Access Compliance Report

Public Rights-of-Way

Intersection ID: 12316	Main Street: ASHLEY_RD	Cross Street: GREENLAND_AV	Location: SW
ADA ID: DAD6277D5139	Ramp Type: Combination1	Initial Pass/Fail: Pass	Overall Compliance: No
		Severity Score: 0.25

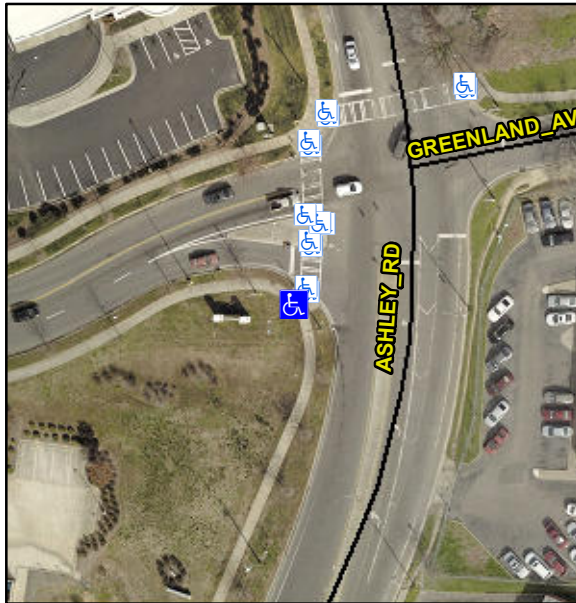
LT RP < 5%

**Not Found, R304.5.3, R304.2.2-Perp,
R304.3.2-Para**

**Remove & Replace Entire Ramp.
Remove & Replace Sidewalk.**
